December 21, 2007
E-25820

Subject: Revision 1 to Transnuclear, Inc. (TN) Application for Amendment 11 to the Standardized NUHOMS® System (Docket No. 72-1004; TAC NO. L24080)

This submittal provides responses to the request for additional information (RAI) forwarded by Reference 1. Enclosure 2 herein provides each of the NRC staff RAI followed by a TN response. Enclosure 3 provides an updated cross reference list between proposed Amendment 10 and proposed Amendment 11 Technical Specifications. Enclosure 4 provides Amendment 11 Revision 1 proposed changes to the NUHOMS® CoC 1004 (Amendment 9), the associated Technical Specifications, and the Standardized NUHOMS® System UFSAR (Revision 9). Enclosure 5 provides updated sheets listing the changed UFSAR pages.

Figure 1-1
PWR Fuel Criticality Acceptance Curve

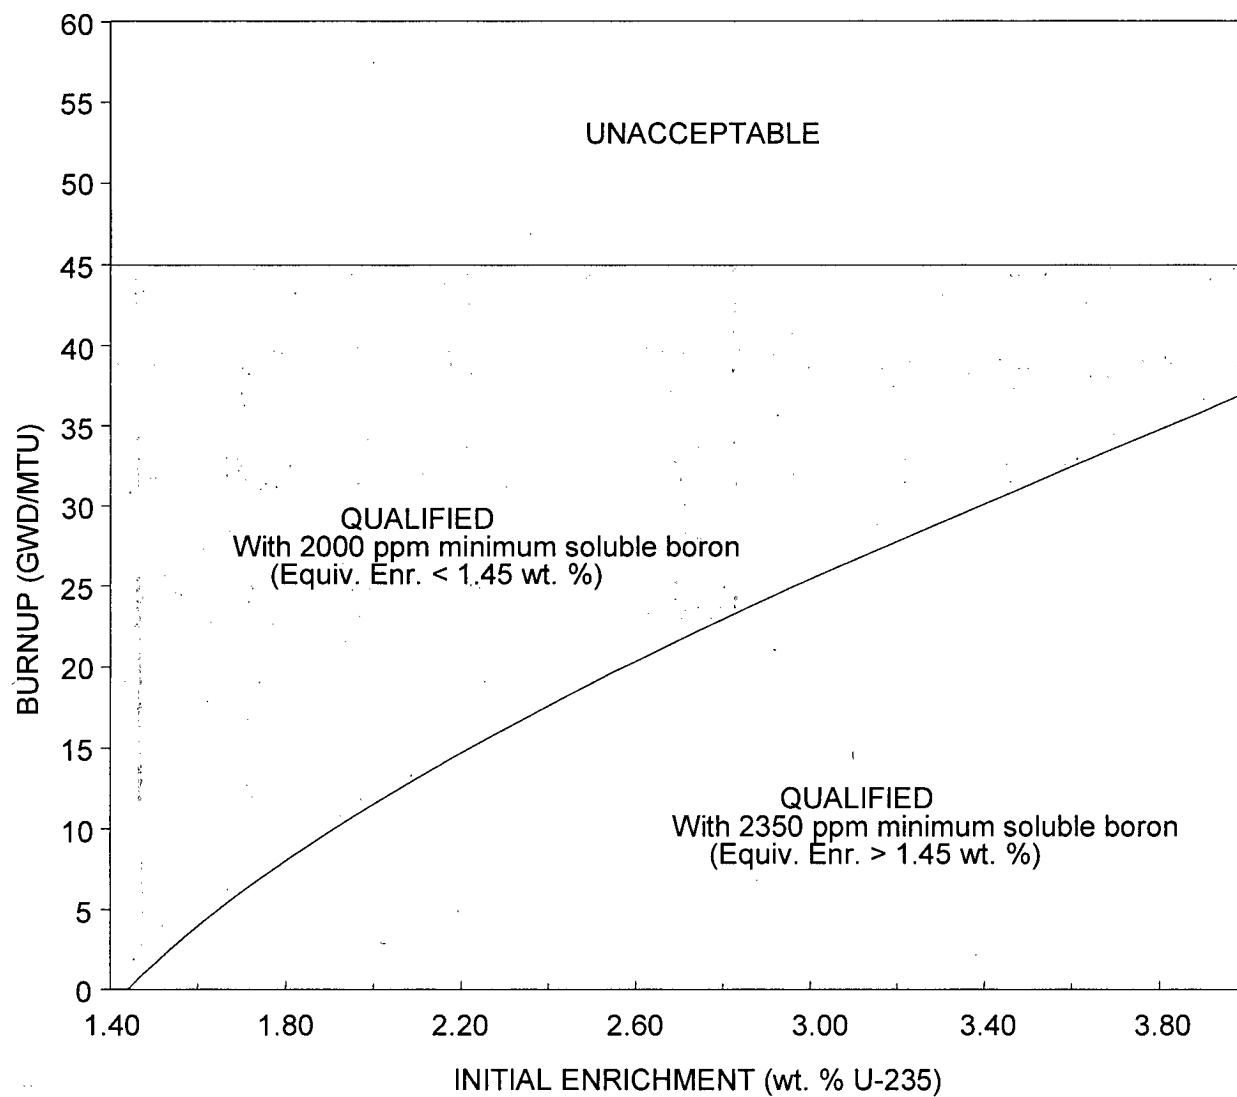
On Page T-2 under specifications for burnup, it refers to Figure 1.1. There is no such figure. The staff believes the correct reference should be to Table 1-2b.

There is no need to reference any figure or table. The reference to "Figure 1.1" is deleted in Technical Specifications Table 1-1b. The corresponding table in the UFSAR (Table 3.1-2) is also changed to match.

**Figure W.5-1**
OS197L TC MCNP Shielding Configuration Description

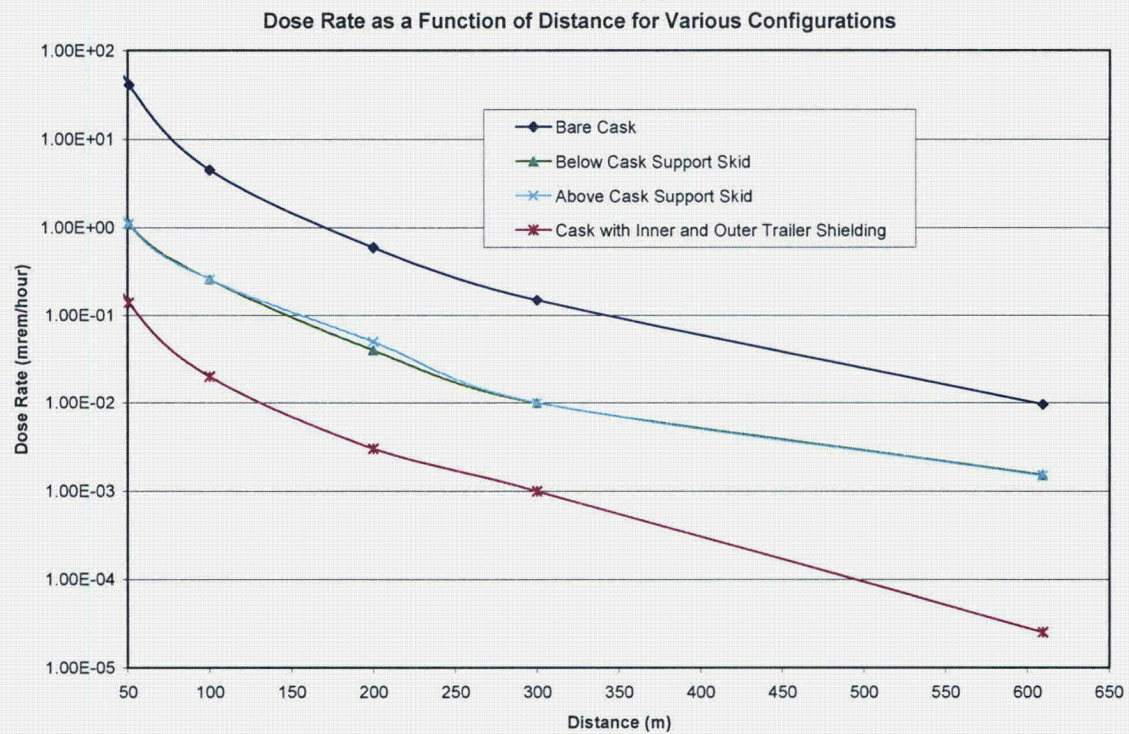
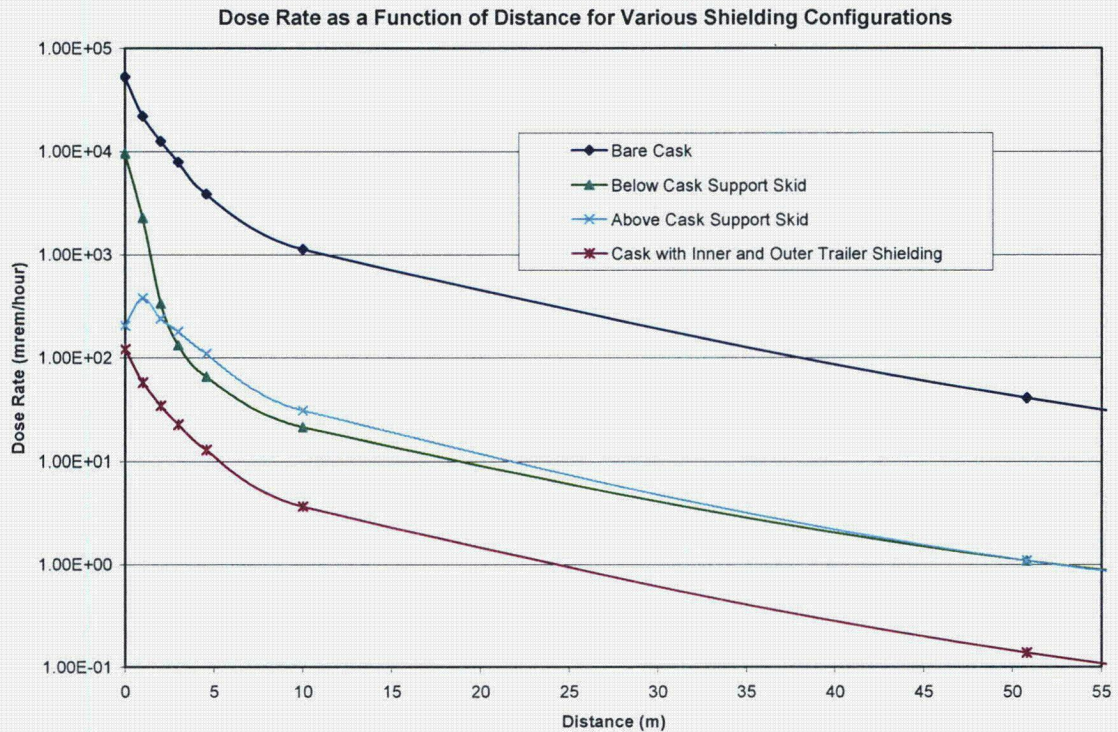
- b. Revise Figure W.5-1 to provide a level of detail similar to Figure M.5-24, showing all axial and radial dimensions modeled in the 3-D MCNP analysis.

- 5-39 Clarify the apparent discrepancy between Figure W.5-1 and Figure W.1-2.

Figure W.5-1 shows that the decontamination area shielding was modeled as 5.5-inches of steel. However, Figure W.1-2 indicates that the decontamination area supplemental shielding is 6-inches thick. Clarify this apparent discrepancy.

See response to 5-38 above. Figure W.5-1 describes the configuration as modeled.
